**Assessment of Hydrogeologic Conditions and
Need for Long-Term Groundwater Monitoring
at the Former Durita Uranium Mill, Naturita, Colorado**

Executive Summary

Gene Peters and Randall Fedors

1. Purpose and scope of assessment

Figure 7. Topographic Map of Durita Site Showing Monitoring Wells. Modification of Downloaded File Obtained from Topozone™ on 07/17/2006.

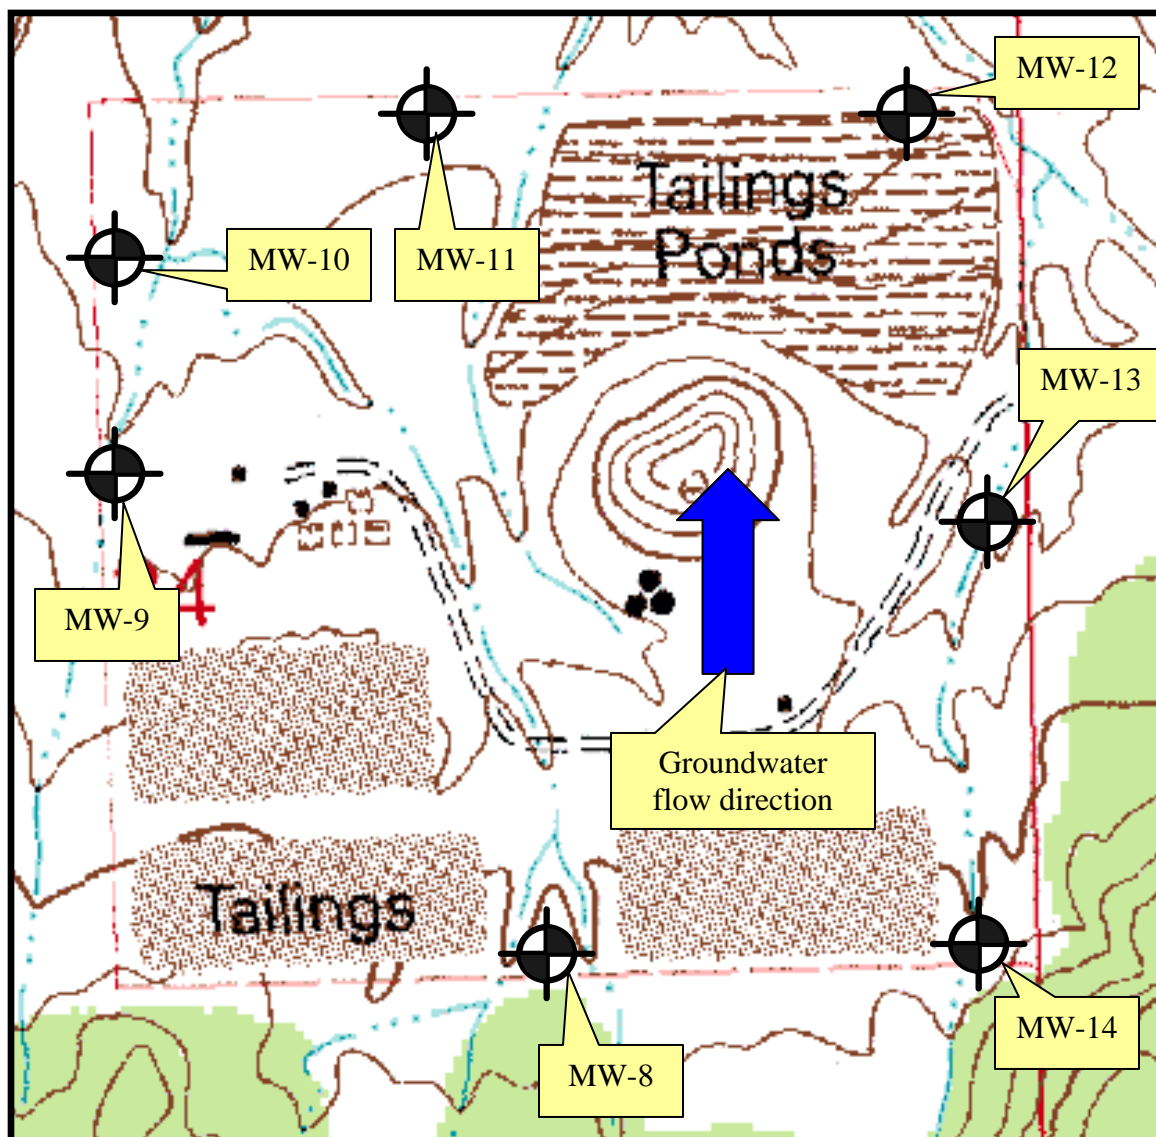
The gradient of the water table is northward towards Dry Creek, but is ill-constrained because it is only defined by seven wells installed along the property boundaries. The seven boreholes outlining the permit area (Figure 7) were drilled into the uppermost aquifer, cased, and screened for monitoring purposes. The monitoring wells are labeled MW-8 through MW-14. The screened intervals intersect the sand layers in the lower portion of the Mancos Formation. Wells MW-1 through 7, mentioned in Fox (1982), were completed during leaching operations in the late 1970s. These wells, however, were improperly completed; thus no data were reported in the available documents.

Of the seven wells monitoring wells constructed in the early 1990s, three are designated as downgradient monitoring wells (MW-10, -11, and -12), two are cross-gradient wells (MW-9, -13), and proximal to sources, and two are upgradient background monitoring wells along the southern Site boundary (MW-8, -14).

Figure 8. Potentiometric Heads for Upstream Boreholes From Two Data Sources, Hecla (1998) and Studios Solutions (1994)

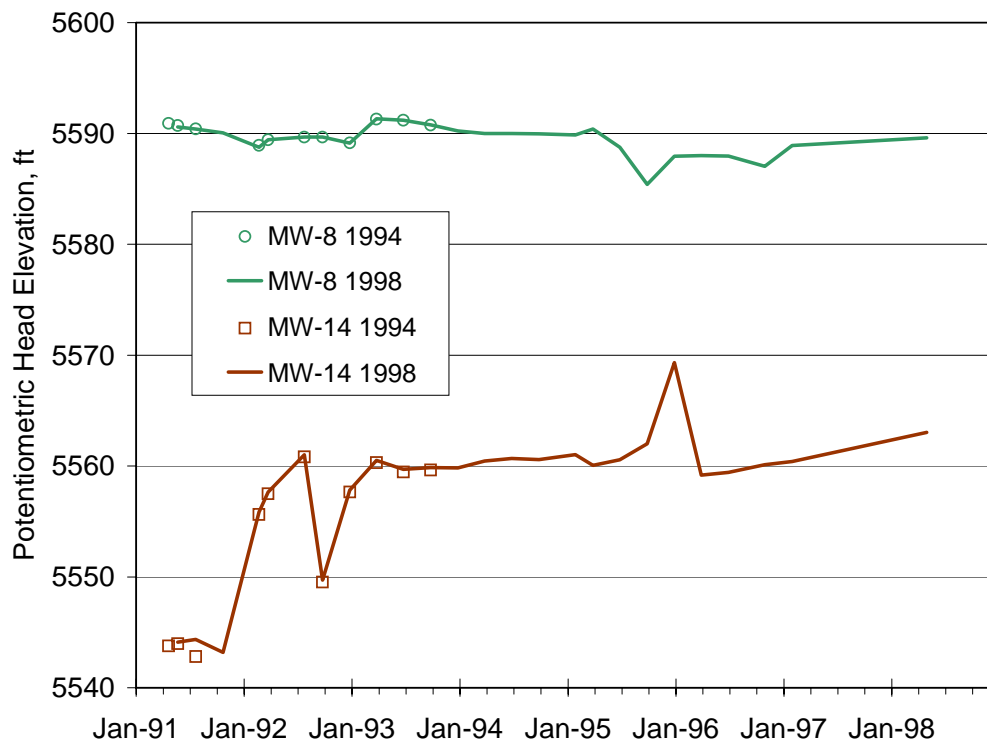
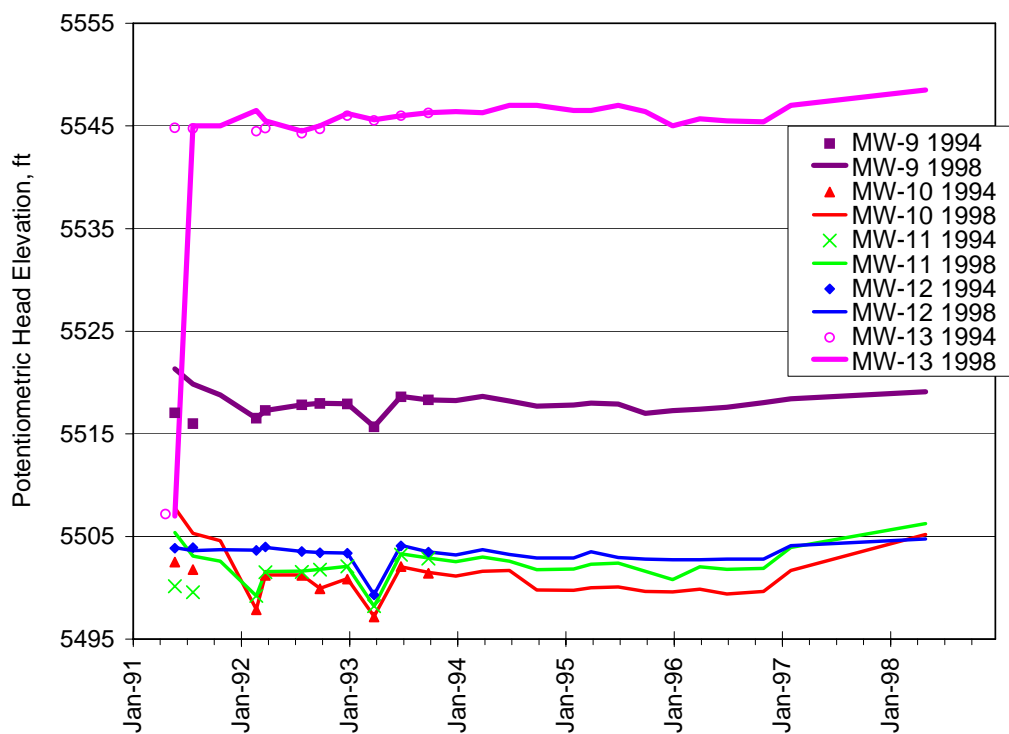
Water levels during the reclamation period, 1992 and 1993, are highly erratic. A prominent downward spike occurred in six of the eight wells late in 1992 (Figures 8 and 9).

The implication is that ground surface activities at the site impacted the water levels. One hypothesis, if preferential flow pathways are presumed to exist, is that re-grading or diversion channel development may have temporarily clogged the flow pathways. Other explanations may be just as reasonably postulated; regardless, it is clear that ground water levels were affected by surface reclamation activities.

Figure 10. Smoothed Quarterly Precipitation Overlaid on Potentiometric Head Data for Upstream Wells

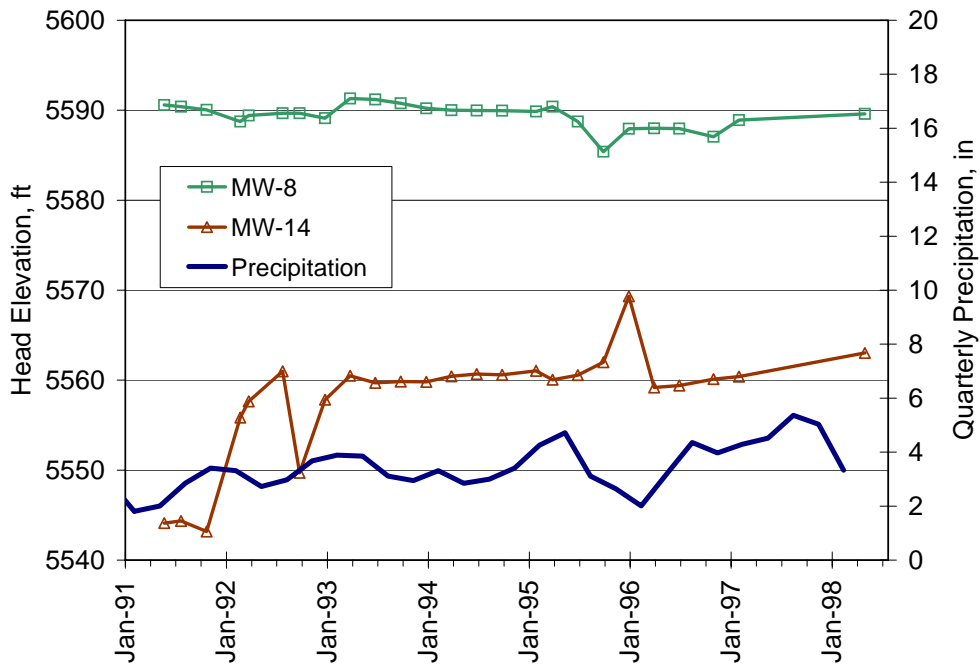
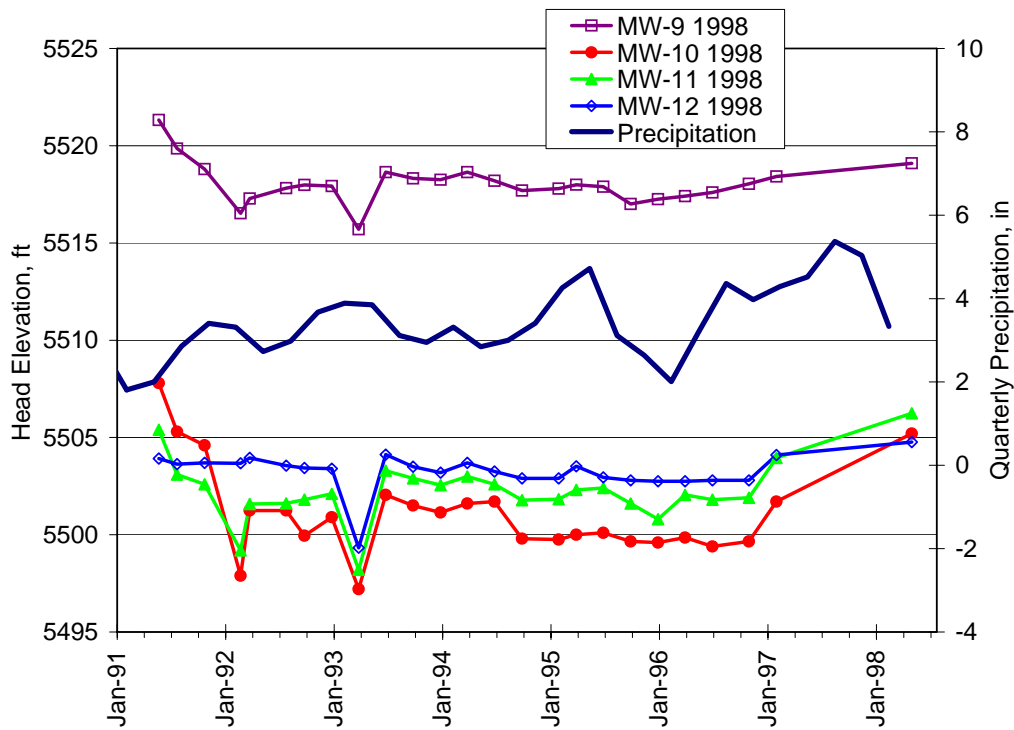
Temporal variations caused by climate stresses are evident when precipitation patterns are overlaid on the water level data (Figure 10 and 11). Two prominent observations are evident. First, a seasonal precipitation pattern is tracked by the water levels, particularly the downgradient (MW-10, MW-11, MW-12) and cross-gradient wells (MW-9 and MW-13). There is a significant dampening of the precipitation signal, and a slight delay in the propagation of the signal. The second prominent observation is that all the wells show an increase in water levels corresponding to the wetter years of 1996 and 1997. The aquifer response to the increased precipitation varies across the site from +1 to +5.5 ft from Nov 1996 to Jan 1998. Note that this period only has three measurements, so seasonal signals are lost. The spatial variation in the seasonal pattern supports a local source for the recharge, rather than an upslope recharge where the sand units intersect the ground surface (related to the synclinal structure). For example, MW-9 and MW-10 are closely spaced with MW-9 upgradient from MW-10. These two wells show the largest and smallest increases over the 1996 to 1998 period; MW-9 increased by 1.0 ft and MW-10 increased by 5.5 ft.
